IN THE CANADIAN PATENT OFFICE

DECISION OF THE COMMISSIONER OF PATENTS

Patent Application 557,756 (class 354-236) was filed on January 29, 1988 for an invention entitled "Programmable Option Select". The inventors are Chester A. Heath et al. The Examiner in charge of the application took a Final Action on May 14, 1992 refusing to allow the application to proceed to patent.

FIG. 6

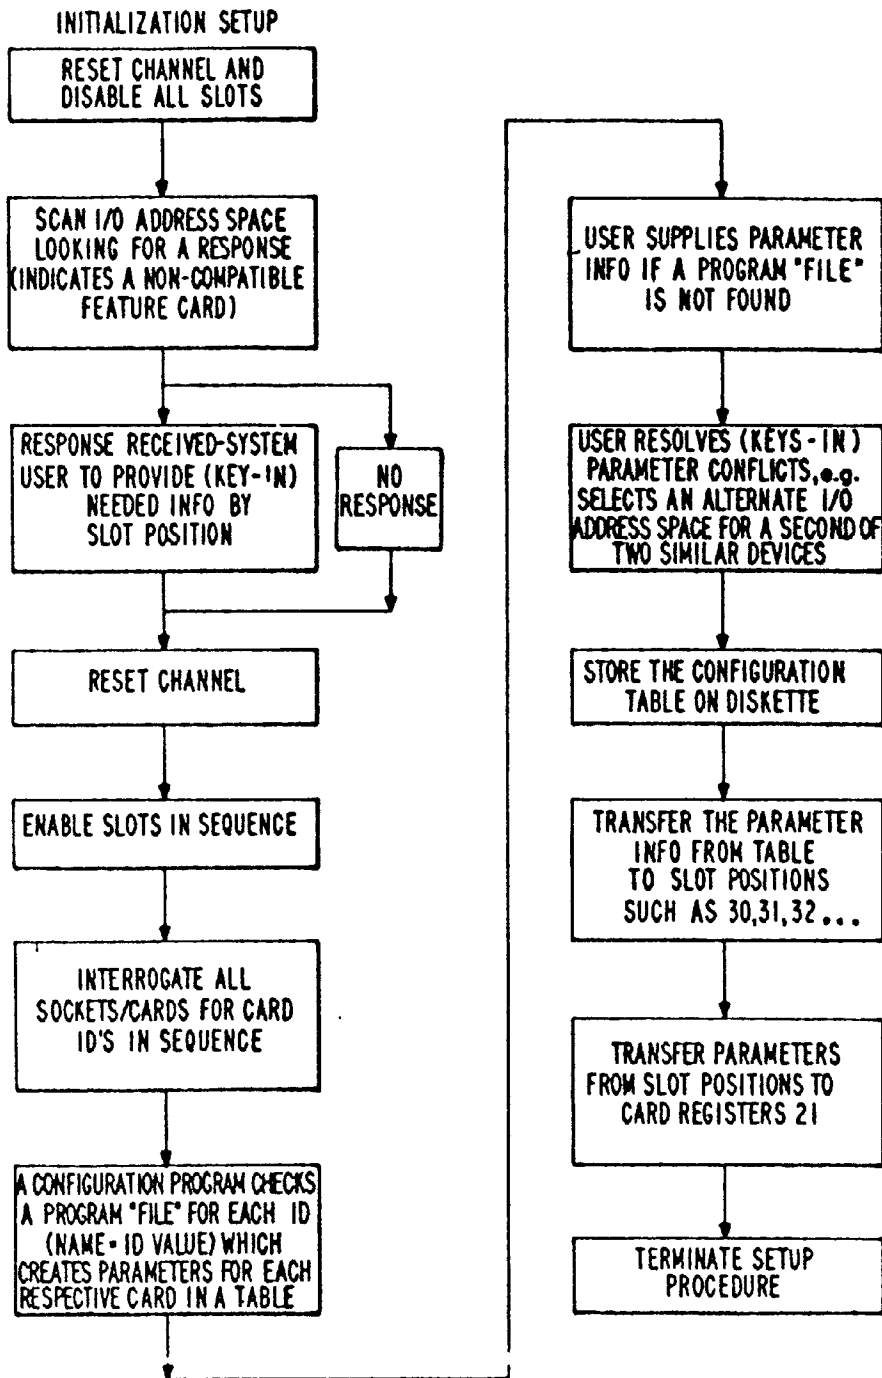
The examiner rejected the application in the Final Action for failure to comply with Sections 34(1) and 37 of the Patent Act and Rule 19(3). The application was held to be objectionable in that the flow chart of Figure 6 does not have written references corresponding to the description on page 7, line 15 to page 8, line 17. The rejection is not based on a demonstrable indefiniteness or insufficiency of the disclosure under Section 34(1) but rather on a desire to fulfil the formal requirements of Section 37(2) and Rule 19(3). In that action the examiner stated (in part):

It is clear from Section 37 that a drawing is required along with a specification and does not lessen the requirement of a specification as set out in Section 34(1). Section 37 requires that the drawing relate to the specification by having written references corresponding with the specification. The application is objectionable in this respect in that figure 6 does not have written references corresponding to the description on page 7 line 15 to page 8 line 17.

In the Final Action the Examiner objected to the flow chart of Figure 6 as not being fully described in the disclosure. There is no objection to the sufficiency of the description in the flow chart. The examiner required amendment of the disclosure in order that all the steps of the flow chart in Figure 6 be listed in the disclosure.

Applicant pointed out in reply to the Final Action that Figure 6 does not illustrate the invention and that it is therefore not necessary for sufficiency of the disclosure to have a description of the same in the disclosure.

The Board agrees with the applicant that Figure 6 lists steps of a prior art initialization setup. The alleged invention resides in the simplification of the power-on routines following power-down occurrences. Figure 6 illustrates one of many prior art initialization steps which are significantly reduced by the invention. The flowchart of Figure 7, indicates a prior art initialization setup under "ID mismatch" and the new procedure according to the present invention is indicated under "ID match". Figure 7 is fully described on pages 6 and 7 of the specification.

The Board finds, therefore, that the alleged invention has been fully disclosed in the specification in accordance with Sections 34 and 37 and recommends that the rejection under Sections 34(1) and 37 be withdrawn.

FIG. 7

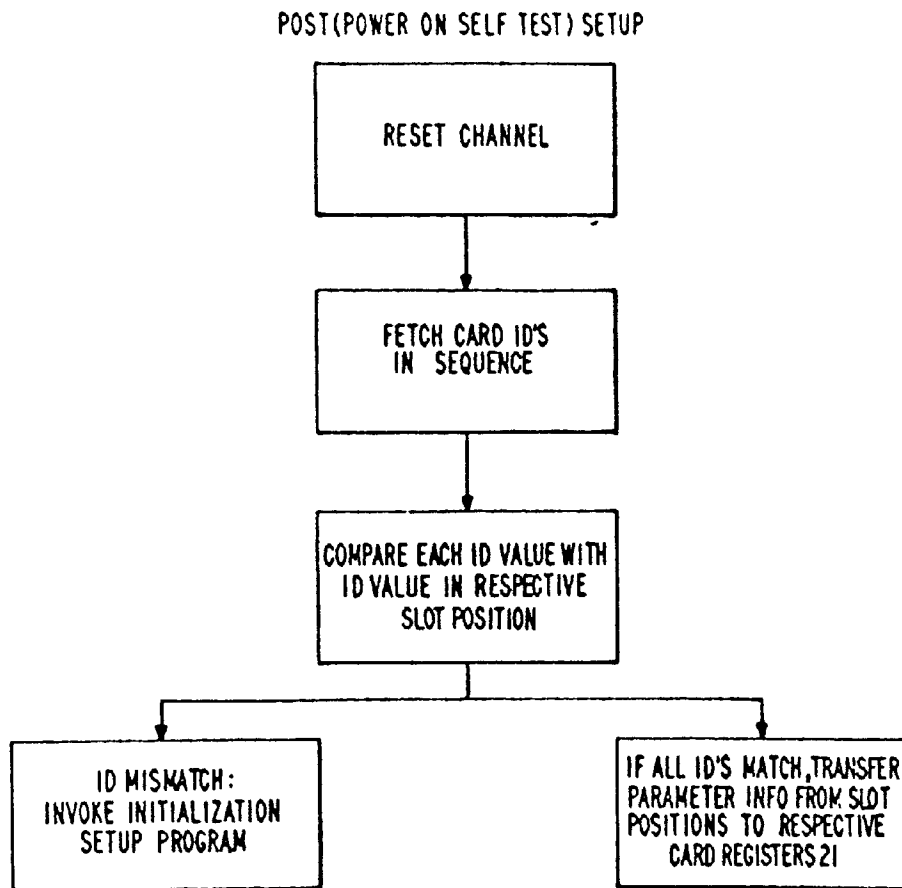
The flow diagram of Figure 7, which is also described on page 6, line 18 to page 7, line 15 of the disclosure shows two possible paths that the setup routine may follow. The right-hand side path transfers parameter data directly from memory slot positions to the respective card registers on successful comparison of the ID values. The left-hand side path follows the lengthy procedure of Figure 6 when the ID values do not correspond.
